Docket Number:	01-AFC-07C
Project Title:	01-AFC-7C Russell City Energy Company
TN #:	210989
Document Title:	Staff Analysis of Proposed Petition to Amend Visual Resources Condition of Certification VIS-10
Description:	N/A
Filer:	Jonathan Fong
Organization:	California Energy Commission
Submitter Role:	Commission Staff
Submission Date:	4/8/2016 2:37:44 PM
Docketed Date:	4/8/2016

**SUBJECT: Russell City Energy Center Project (01-AFC-7C)
Staff Analysis of Proposed Petition to Amend Visual Resources
Conditions of Certification VIS-10**

RUSSELL CITY ENERGY CENTER (01-AFC-7C)

Visual Resources Staff Analysis

VISUAL RESOURCES - FIGURE 1

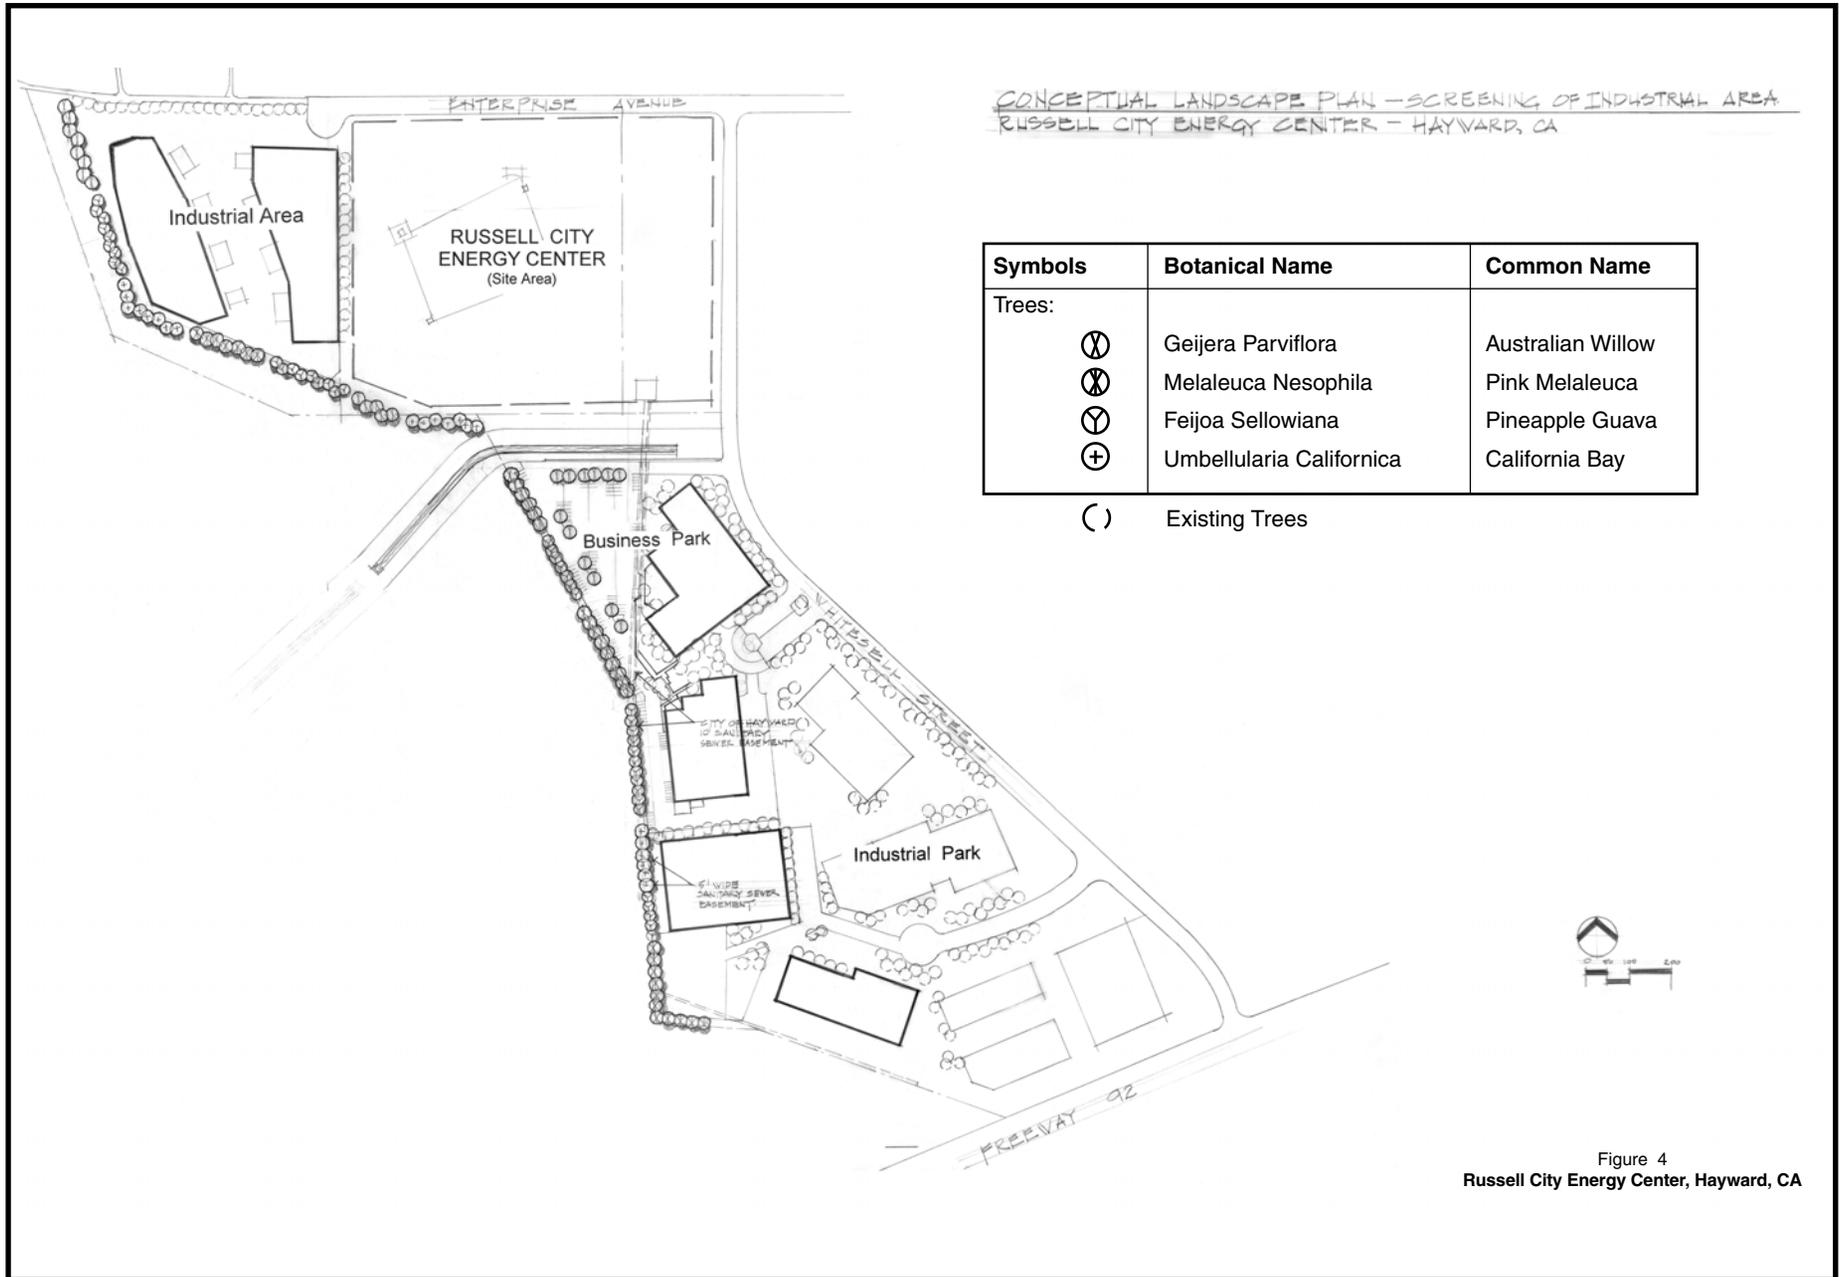
row of evergreen trees along the west edge of the Industrial Corridor, starting at the warehouse complex to the west of the RCEC and continuing southerly along the parking lot of the Whitesell Business Park. See **Visual Resources Figure 1** – Conceptual Offsite Landscape Plan, June 2002.

During the original licensing proceeding, the project owner contacted landowners to obtain their permission and cooperation for the use of their land or leasehold for offsite tree planting. In 2002, Calpine received approvals from landowners to plant the trees.² However, in 2012, the project owner discovered new landowner restrictions and

property constraints made it infeasible to plant trees on many of the properties - see table below.

Because of landowner restrictions and property constraints, the PTA proposes another option to reduce the high color contrast of exterior walls on offsite warehouses. Instead of growing trees to screen or partially screen the view of exterior walls, the RCEC project owner proposed painting selected exterior walls in muted colors, and planting a row of trees on a city-owned parcel, to reduce their contrast.

VIS-10 The project owner shall take all feasible steps to implement a color treatment and landscape concept plan (plan) that includes five (5) existing offsite buildings (warehouses) along the eastern edge of the Hayward Regional Shoreline that have publicly visible exterior walls that face or nearly face the Hayward Shoreline Interpretive Center - Key Observation Point (KOP) 2.
